IMPACT OF DATA PRESENTED IN DRAFT  
NUREG-0630  
ON DONALD C. COOK UNIT 2 LOCA ANALYSIS

ATTACHMENT B  
TO  
AEP:NRC:00322B  
DONALD C. COOK NUCLEAR PLANT UNIT NO. 2  
DOCKET NO. 50-316  
LICENSE NO. DPR-74

Revisions to Limiting Condition of Operation (LCO) 3.2.2,  
Figure 3.2-2 and Basis Item 3/4 2.1 - Unit No. 2

FIGURE 3-2 K(Z) - NORMALIZED  $F_Q(Z)$  AS A FUNCTION OF CORE HEIGHT

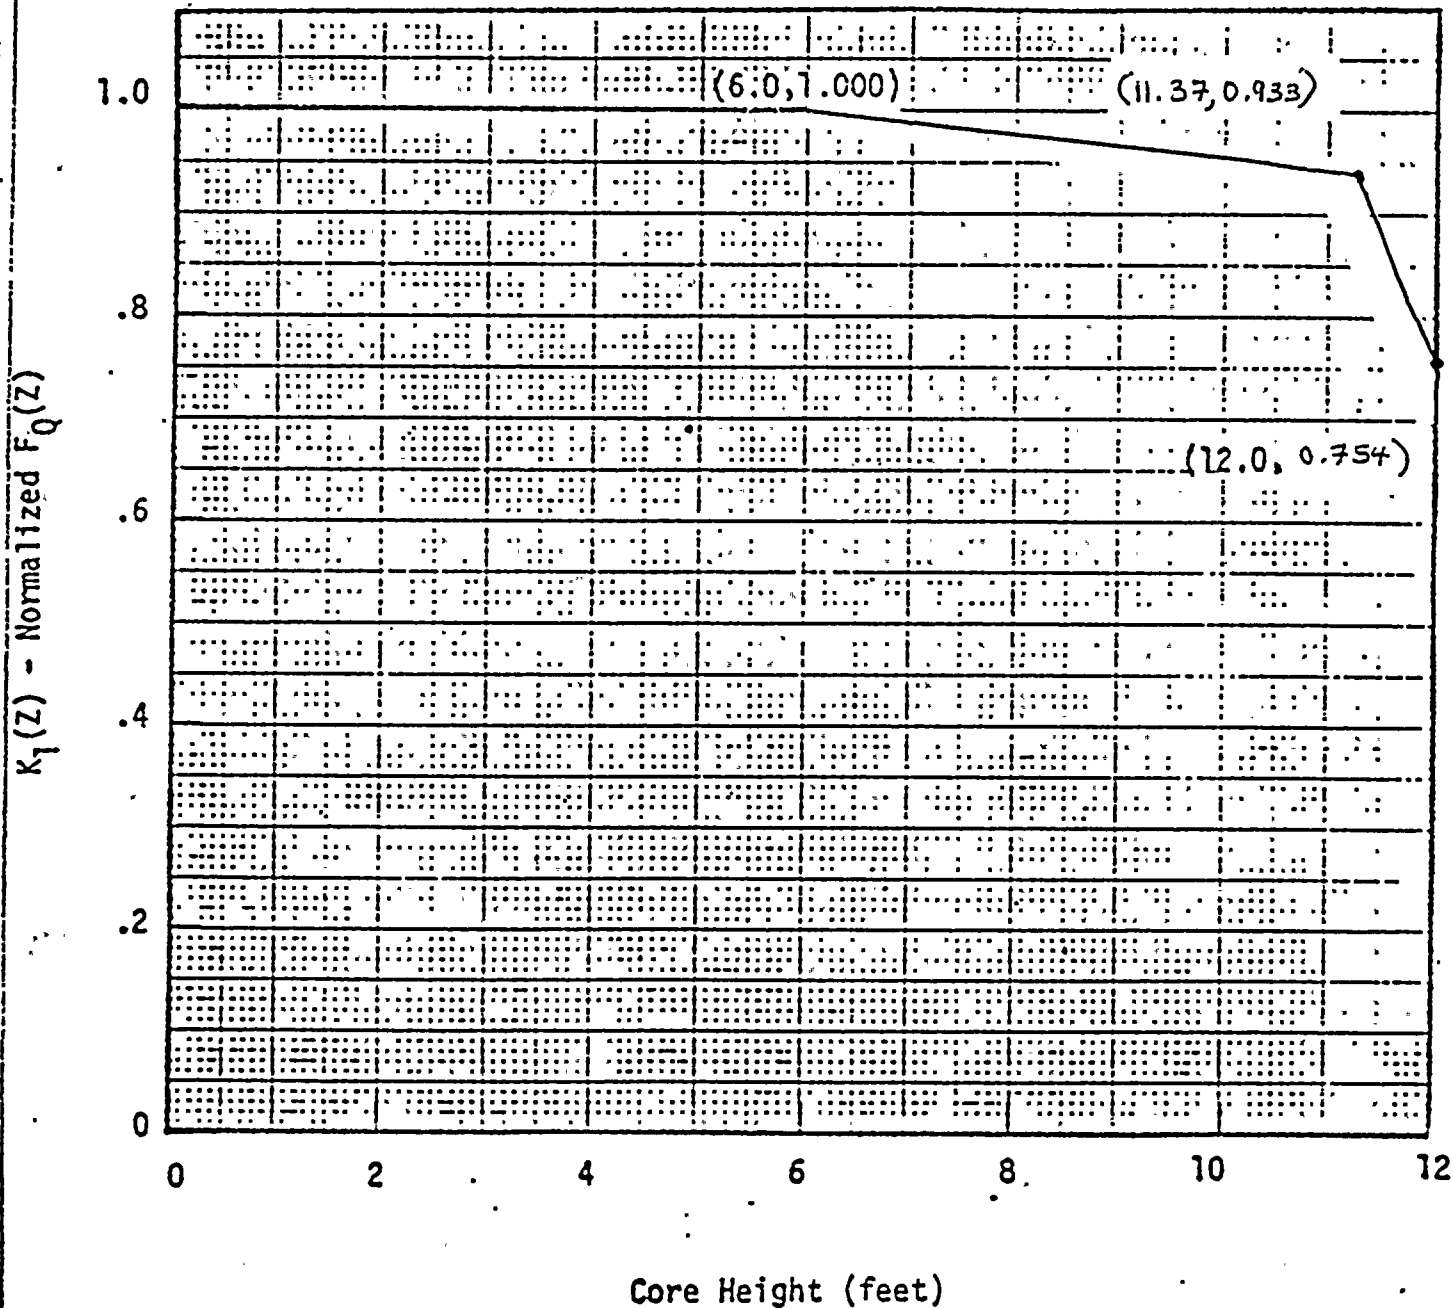
This change involves lowering the maximum allowable  $F_Q$  (Z) limits. The maximum value is being reduced from 2.32 to 1.99. Until the 1.99 limit was established via the evaluation discussed in Attachment A of this letter, an administrative limit of 2.11 was employed in compliance with the NRC order which followed the discovery of a 'logic inconsistency' in the metal-water reaction calculation of the Westinghouse ECCS Evaluation Models. The 2.11 administrative limit was established after a new Westinghouse ECCS analysis (using the October 1975 Model with the metal-water correction) was performed. These analyses results were transmitted to the NRC on April 28, 1978. A reanalysis of Donald C. Cook 2 using the February 1978 Model resulted in a maximum  $F_Q$  of 2.02. This base analysis was used to establish the new 1.99 limit. This change assures the continued protection of the public health and safety.

Basis:  $F_Q(Z) \times P$  ECCS limit of 1.99

FIGURE 3.2-1 AXIAL FLUX DIFFERENCE LIMITS AS A FUNCTION OF RATED THERMAL POWER

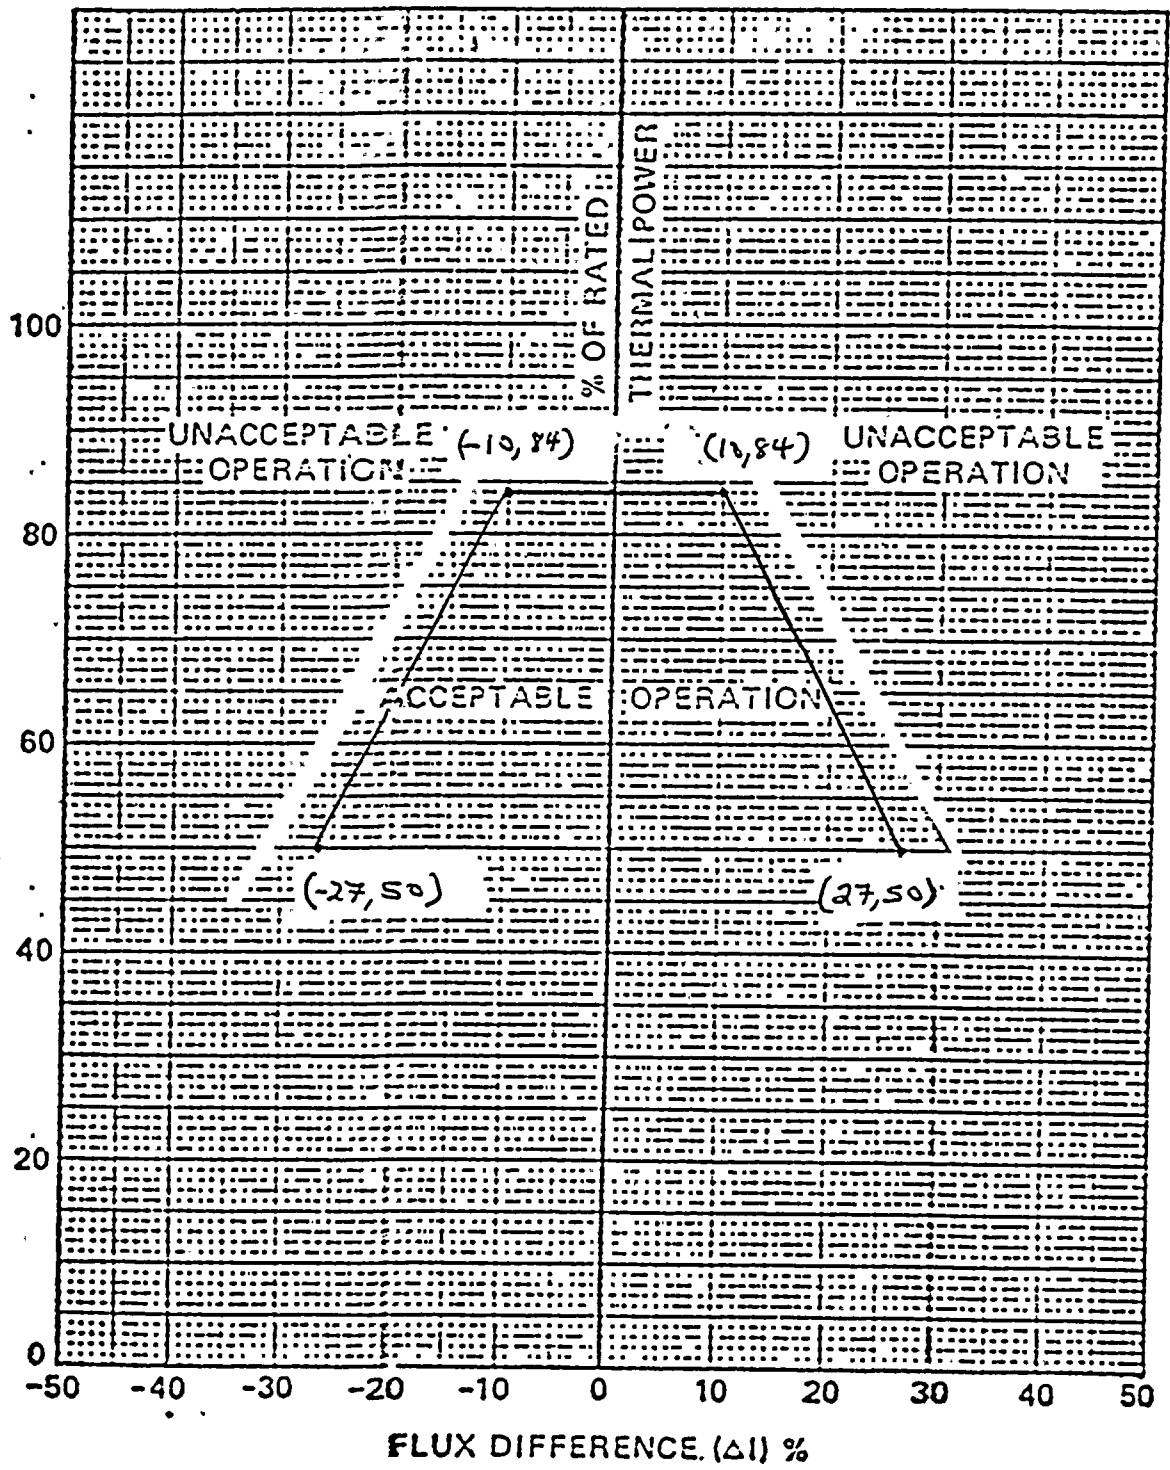
This change involves keeping the upper power limit for the taking of action at 84% Rated Thermal Power. The change requested in AEP:NRC:00297 was to raise the limit to 90% RTP. This technical basis for the change is the same as that of Change No. 1 above. This change assures the continued protection of the public health and safety.
